**Fire Risk Assessment**

**1-10 Trays Hill Close**

Version 5

20 September 2024

## Task 1

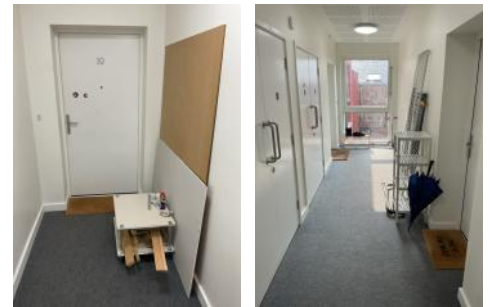
Source Version	1
Category	Fire Prevention
Sub Category	Lightning
Action Required	The lightning protection should be periodically inspected by a competent person, to the frequency recommended in BS EN 62305.
	<p>Version 5. 20/09/24 This task remains outstanding.</p>
Priority	Low
Status	Identified
Owner	Neighbourhood Services
Due Date	03 July 2020

### Task 4

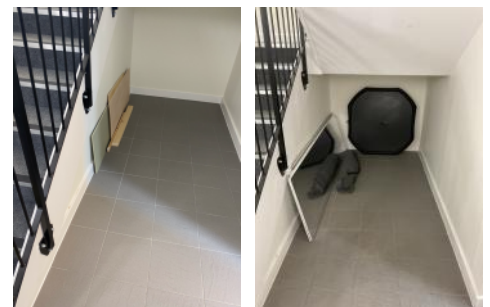
Source Version	2
Category	Fire Prevention
Sub Category	Housekeeping
Action Required	Although the amount of combustibles currently in communal areas is not unreasonable, the premises should be monitored to ensure the amount of items does not build-up.  Version 5. 20/09/24 This task remains outstanding.
Priority	Medium
Status	Identified
Owner	Neighbourhood Services
Due Date	03 December 2020
